St. Lucie Unit 1  
Docket No. 50-335  
Proposed License Amendment  
RCS Minimum Flow and TS Update

ATTACHMENT 3 to FPL Letter L-98-283

**ST. LUCIE UNIT 1 MARKED-UP TECHNICAL SPECIFICATION PAGES**

FIGURE 2.1-1: REACTOR CORE THERMAL MARGIN SAFETY LIMIT - FOUR REACTOR COOLING PUMPS OPERATING

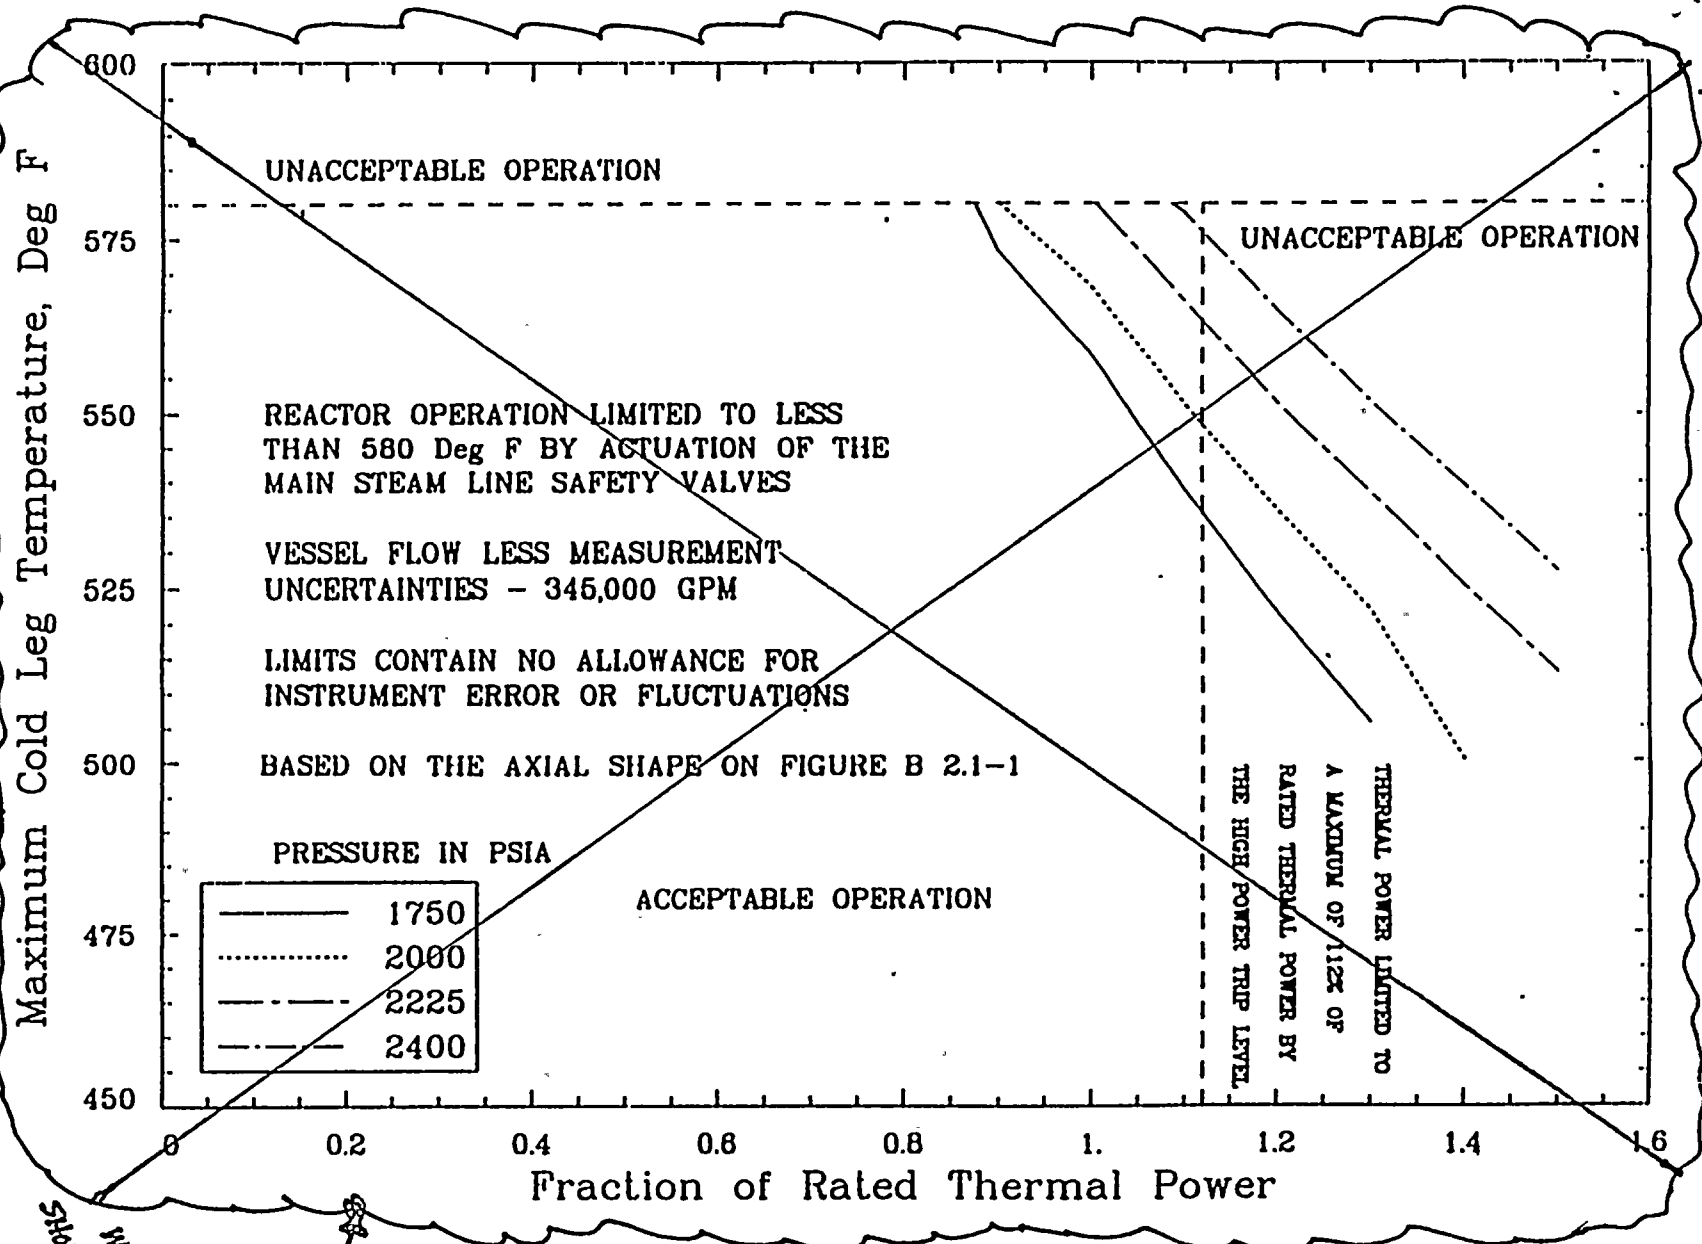
REPLACE WITH INSERT-A  
 WITH INSERT-A  
 WITH NO WORKS

REPLACE  
WITH INSERT-A  
SHOWN ON NEXT PAGE

INSERT - A

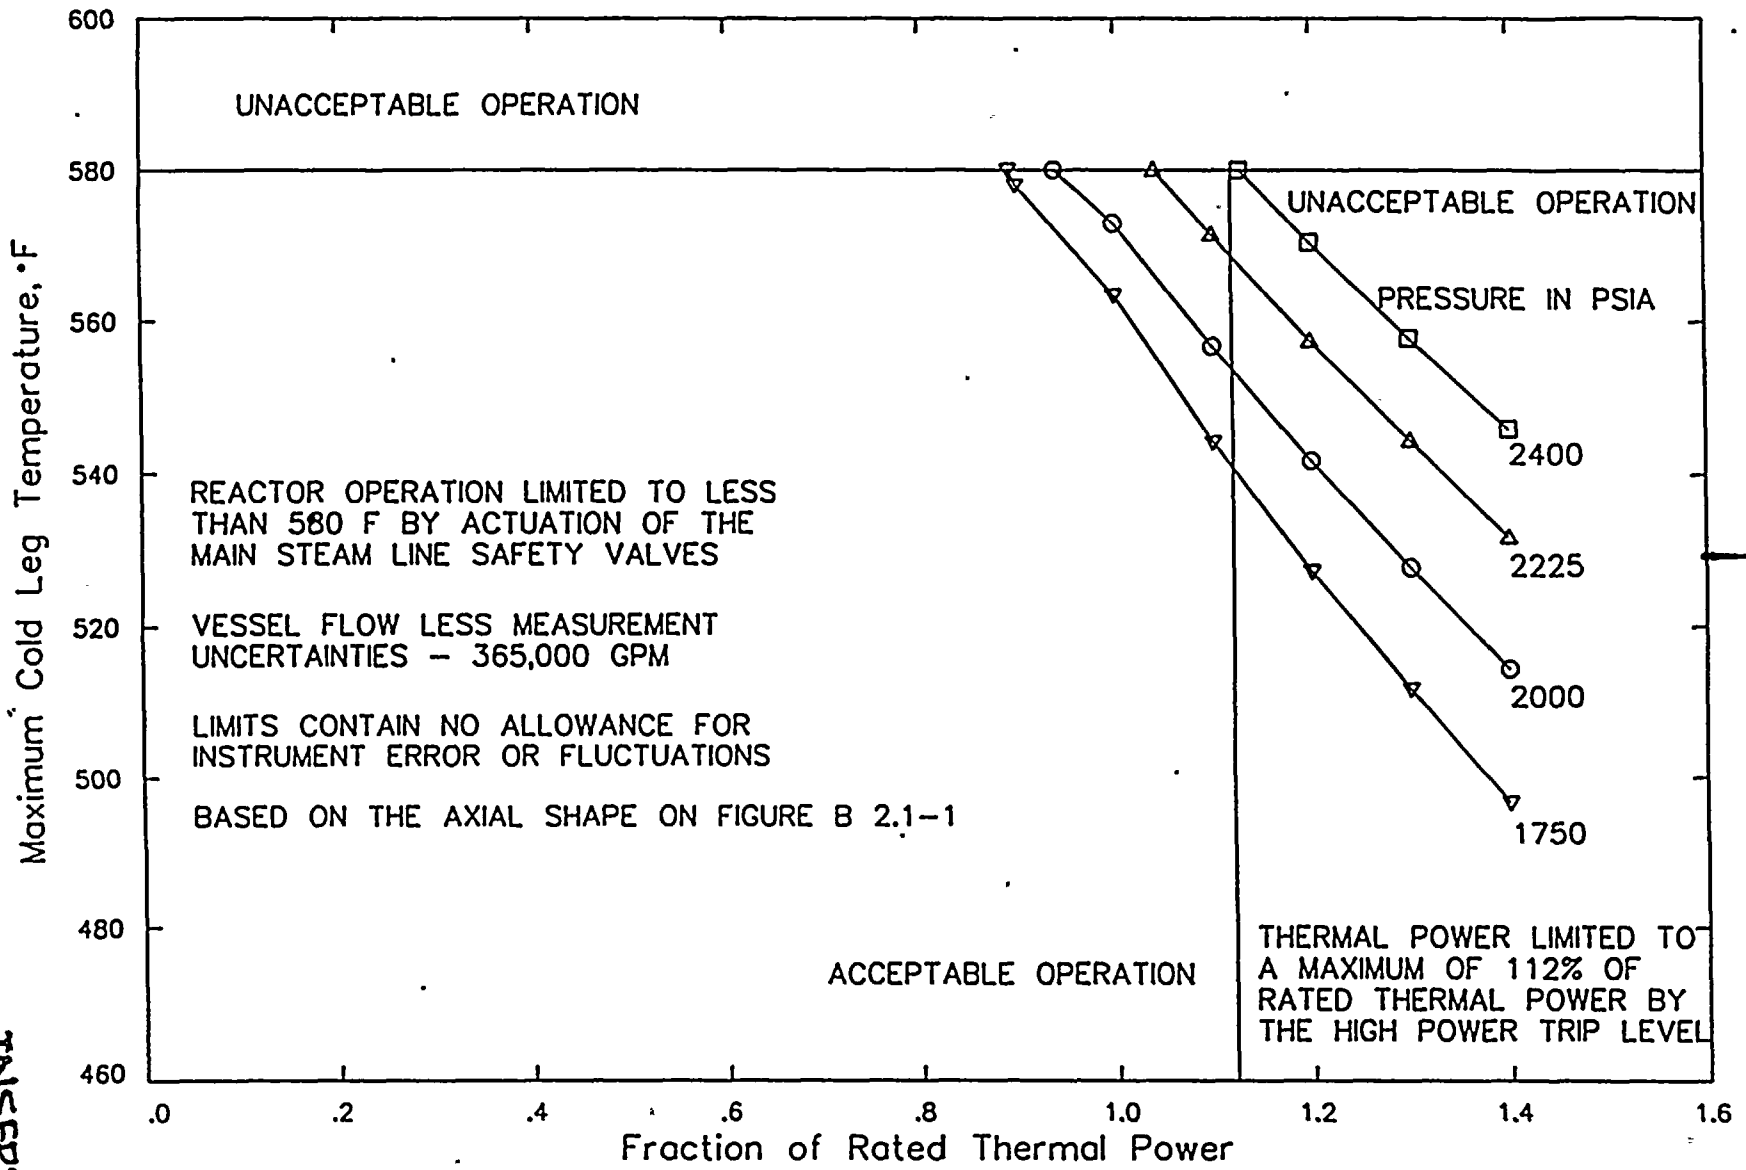
INSERT - A (Revised Figure 2.1-1)
